Washington County Citizen Participation Organization 1
3270 NW Kinsley Terrace
Portland, OR 97229

To Paul Schaefer, Washington County LUT

Regarding Development Application L2100351

CPO 1 has reviewed the application and has these comments.

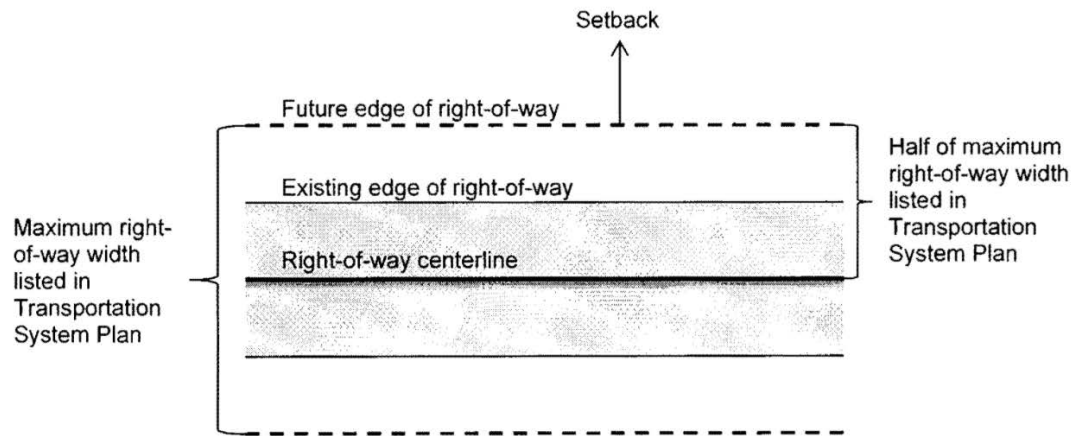
Please note—the applicant misstates the ROW requirement for urban arterials as requiring only a minimum of 10 feet of right-of-way dedication, when instead the ROW dedication for half-street improvements is to meet county arterial standards.

use: NW Thompson Road is shown on the TSP as an arterial roadway. As shown on the Preliminary Plans (Exhibit A), an 11-foot right-of-way dedication is planned to provide for the full planned width as required for an Arterial roadway. This criterion is met.

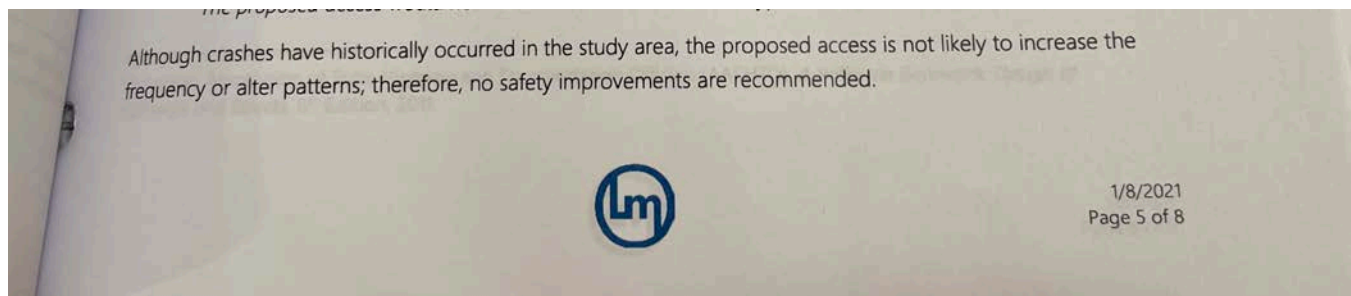
The proposed development's access roadway is 315 ft from a neighboring roadway to the west. The required spacing for roadways entering an arterial is 600 ft. This condition is not met.

Instead of acknowledging concerns about closely spaced streets and engaging in a discussion regarding risk mitigation, the applicant mentions the troublesome roadway safety information and crash data., but fails to address and minimizes the safety concerns related to cars from the proposed development entering and exiting the roadway at this site, instead stating only:
